Enclosed you will find an original and five (5) copies of the response to the Commission Staff's Second Supplemental Data Request on the revised application of South KY RECC's certificate of convenience and necessity to construct a new headquarters facility in Somerset, Kentucky.

RESPONSE TO COMMISSION STAFF'S
SECOND SUPPLEMENTAL DATA REQUEST

OFFICE BUILDING - FURNISHINGS PLANS
CORPORATE OFFICE FACILITIES
 SOUTH KENTUCKY
 RURAL ELECTRIC COOPERATIVE CORPORATION
 SOMERSET, KENTUCKY

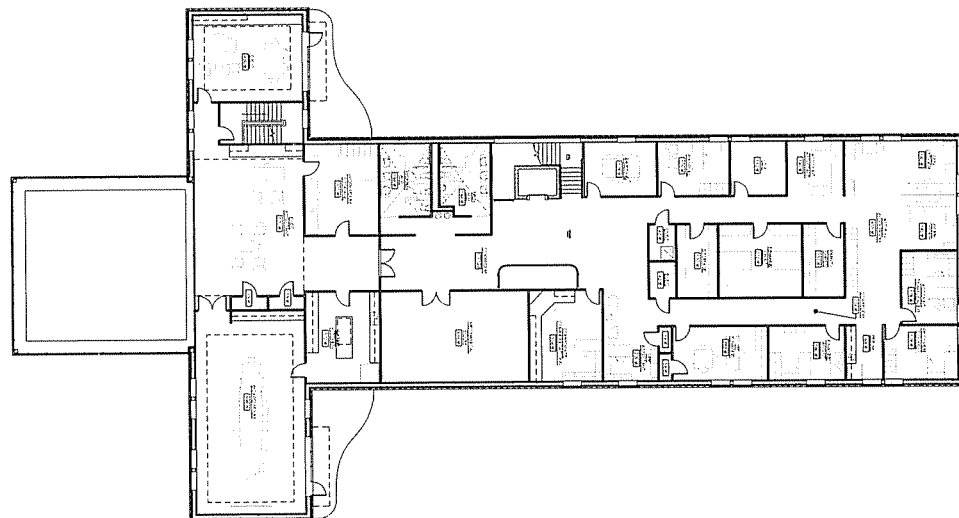
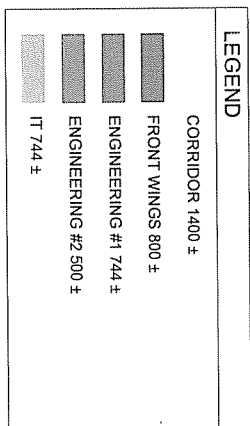
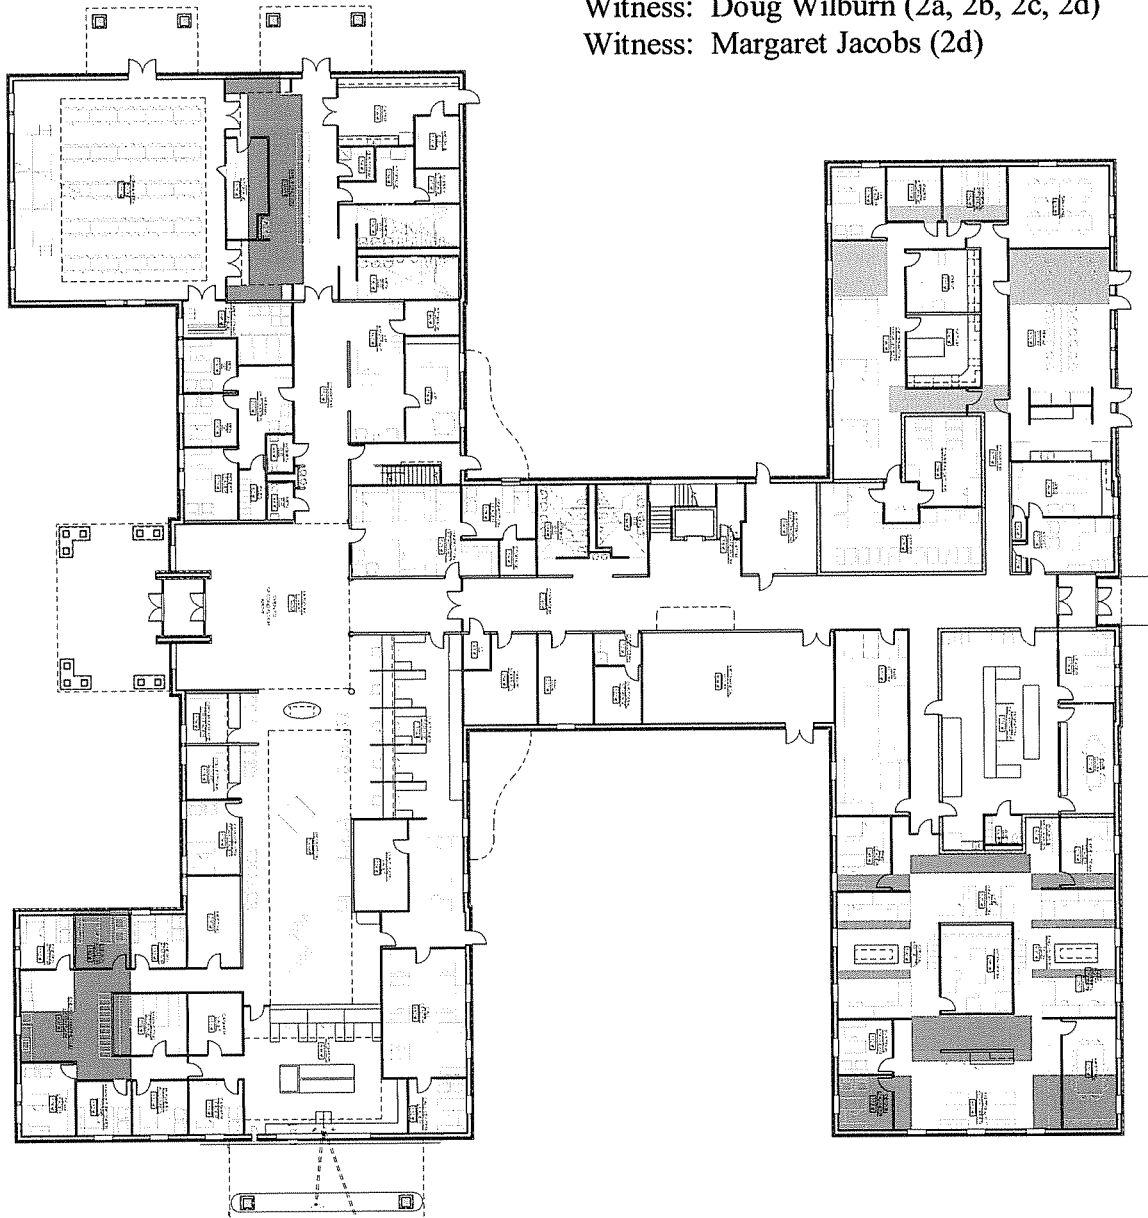
- Q. (2) Refer to South Kentucky's response to Staff's Supplemental Data Request, Item 2(b). South Kentucky states that it analyzed the following four areas for reduction: i) corridor widths; ii) community rooms and marketing wings; iii) engineering department; and iv) information technology department.

- a. Provide the papers, worksheets, calculations, and any and all documentation establishing the estimated cost savings associated with each of the four areas listed above.

- R. 2(a) Reference color coded floor plan Item No. 2 pages 4 thru 5 of 8. These plans identify locations where reductions were proposed and the corresponding square footage for each of the four areas. Then refer to Item No. 2 Attachment A page 6 of 8 which states the dollar values associated with each of the areas established by the Architect/owner for reduction. D. W. Wilburn used square foot cost associated with the As Bid drawings as a baseline and adjusted the square foot cost down to be conservative with the adjusted square foot deduction. For example, reducing the corridor width of the Office Building would not provide reduction in lighting, HVAC, or wall in place; therefore would not merit the entire As Bid square foot cost of the Office Building. For a second example, reduction in the outdoor transformer dock area by one bay would not constitute the total square foot cost of the warehouse since the area is not a conditioned space. With the square foot cost known through the prior

Please see Item No. 2 Attachment C page 8 of 8, which states the dollar values associated with each of the areas established by D. W. Wilburn, Inc. for deduction. D. W. Wilburn provided this value engineering to the owner because we saw the value in not redesigning the office building. The owner would accrue additional design fees in the redesign of the office building. Many of the items D. W. Wilburn value engineered could be provided to the owner without a new building design and primarily consisted of exterior amenities. These exterior amenities could be provided at a later date and would not be detrimental to the overall project. For instance, landscaping could be provided through SKRECC own forces or contracted out at a later time and this would not be detrimental to the program or accrue additional design cost (landscape design completed). For instance, providing HD asphalt in lieu of concrete provides a cost saving without redesign or reduction in the owner's program. Concrete curbs could be reduced to provide a cost savings to the owner without major redesign to the grading and/or storm plans. A stone aggregate surface could be provided in lieu of a concrete surface at the transformer lay down area; the stone aggregate surface may be used in the future for the base course of concrete pad. Roller shades and blinds, site furnishings, exterior fencing, and masonry seat wall, etc. could be provided as the owner deemed necessary as well. These reductions provided a value savings, provided deductions without extensive design time and fees, and provided the owner the ability to enhance its grounds without extensive renovations / modifications when future opportunities deemed feasible.

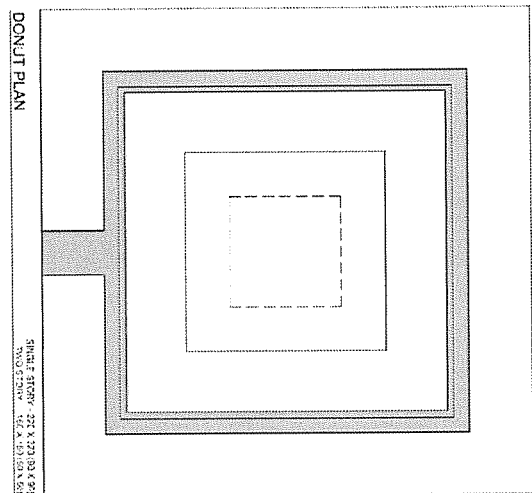
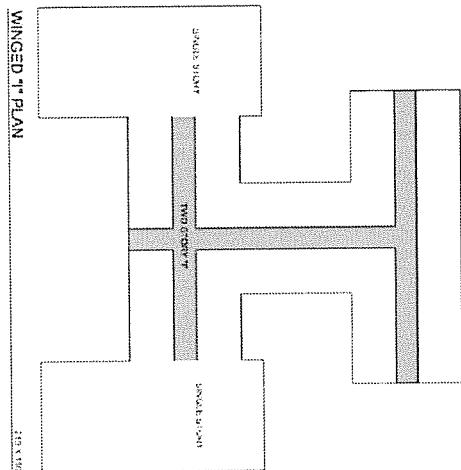
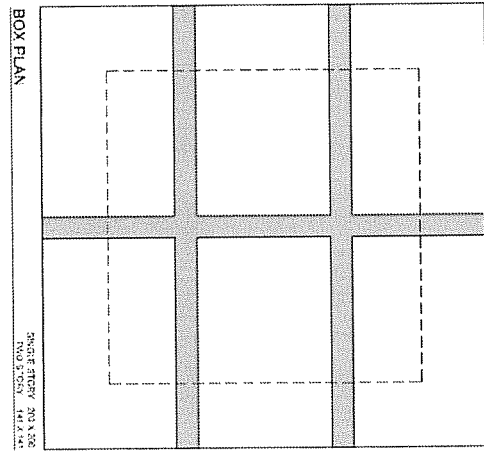
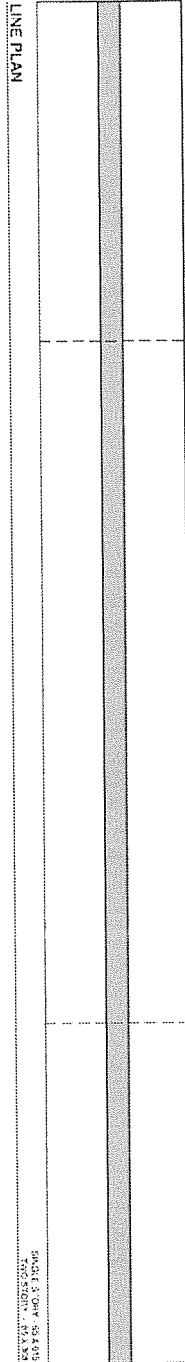
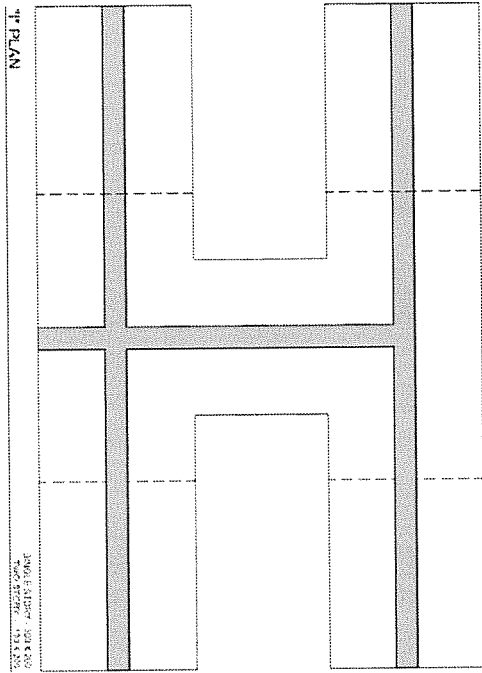
- d. In paragraph 4, South Kentucky states that the various building diagrams provided included plan configuration studies, volumetric studies, and a selected conversation about building envelope materials. Provide copies of all documentation referenced in your response that was not included with the building diagrams.

R. 5(d) Please see Item No. 5 attachments E-1, E-2, and E-3 pages 36 thru 38 of 59 concerning building envelope cost comparisons. Also, refer to attachments Item No. 5 pages 39 thru 42 of 59, which reflect plan configuration studies, volumetric studies and building diagrams.

Total Wall R Value is based on 6" 18 ga Metal Stud spaced at 16" on center, 5/8 interior gypsum board taped and finished, interior air film, wall air space, 5/8 Exterior Densgold sheathing, continuous air barrier, 2.5" Icynene Insulation, air space, and brick veneer. Additional steel package scope not included in dollar unit price.

**The metal stud wall assembly above is not load bearing, therefore, the building steel package will be enhanced to consist of additional columns, spandrel beams, and sheer wall bracing.

**Concerning structural strength and wind load capacity of the above wall types, all of the wall types can be designed to meet current building code requirements for this building class, however, the construction and design of the building shall change to structural steel bearing.
